TOLEDO-LUCAS COUNTY PLAN COMMISSIONS

REF: PUD-4005-19

SUBJECT: Request for an Amendment to a Planned Unit Development, originally approved by Ord. 240-77, for an apartment complex at 6047 Whiteford-Center Road.

ELEVATIONS

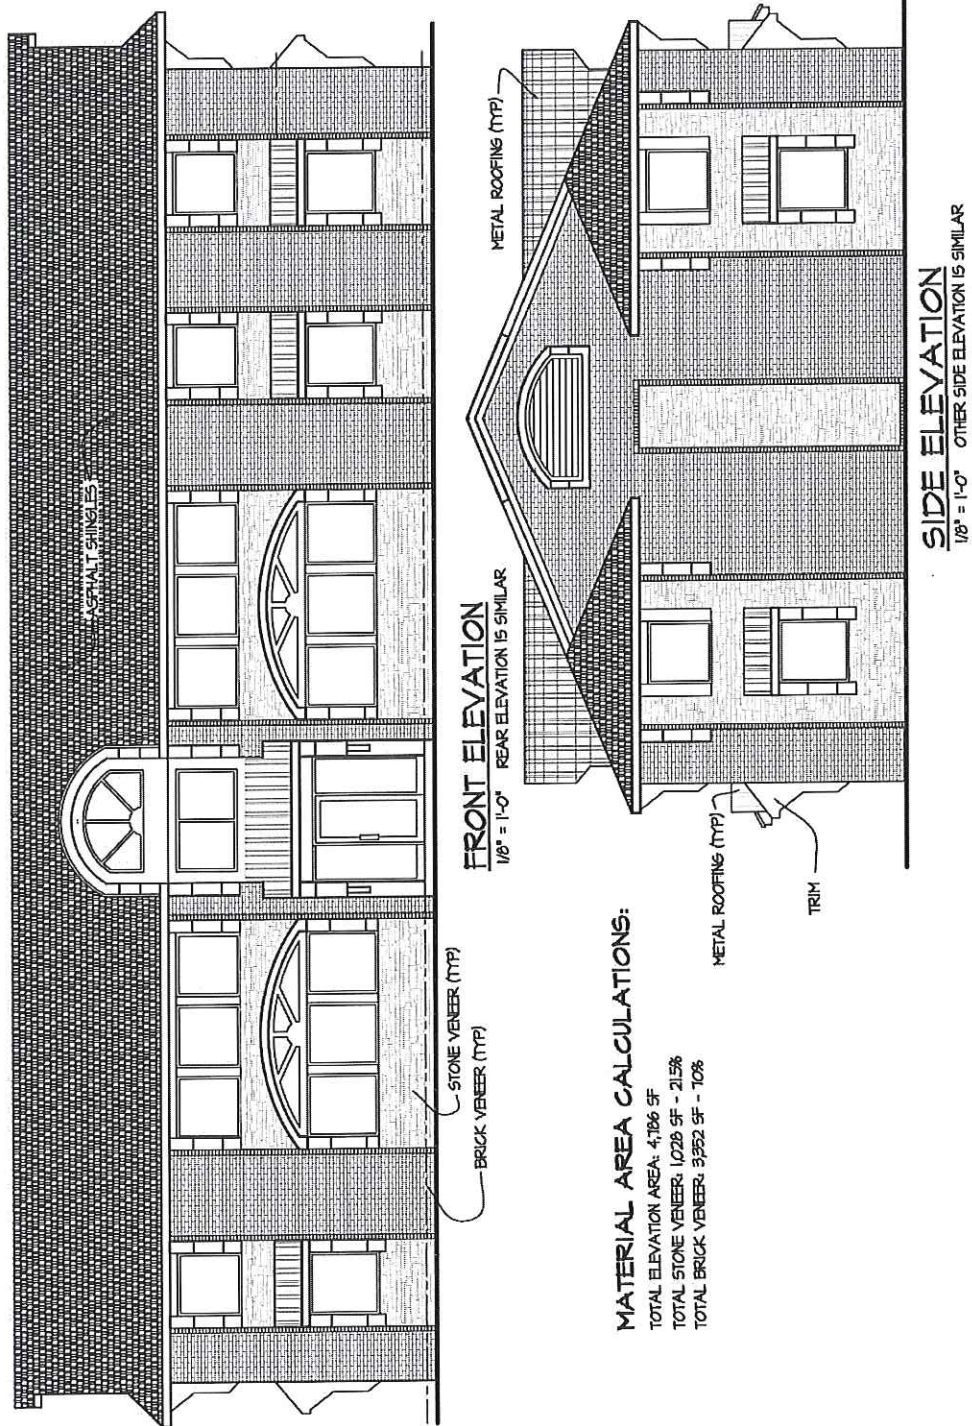
46. The building design shall meet the requirements of TMC§1109.0500 – *Building Façade Materials and Color*. Predominate exterior building materials shall be high-quality materials. For facades visible from the public right-of-way, predominate materials must comprise at least seventy-five percent (75%) of the total wall area of the façade. Exterior building materials shall not include concrete blocks, concrete panels or wood sheet goods as a predominant material. EIFS may not constitute more than 15% of the exterior for facades visible from the public right-of-way. **Acceptable as depicted on elevations submitted.**
